From: Annie_Chang@adt.com.tw [mailto:Annie_Chang@adt.com.tw]
Sent: Thursday, June 08, 2006 2:37 AM
To: steve.cheng
Subject: Re : TCB Review Comments for (C06-0607a- H41KB27RF004- Lite On 27MKeyboard)

主旨 TCB Review Comments for (C06-0607a- H4IKB27RF004- Lite On
27M Keyboard)

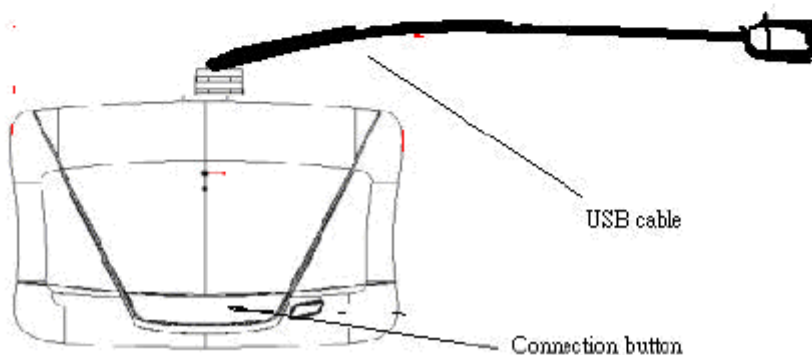
Question #1: User manual show a USB cable connected to the keyboard, please explain what is this cable for? Will this cable be connecting to PC? If yes, than this device will be considered as a PC peripheral too and its Part 15B portion needs to have DoC or Certification too.

I had upload the modified documents to server. Please find them. Thank you.
About the question 2, I upload two bandege plots to server for keyboard and mouse.
And the question 1, do you mean the 2th drawing on page 4 in the user's manual? That is receiver.

The client was added a note on page 4 in user's manual as follows:

Receiver:
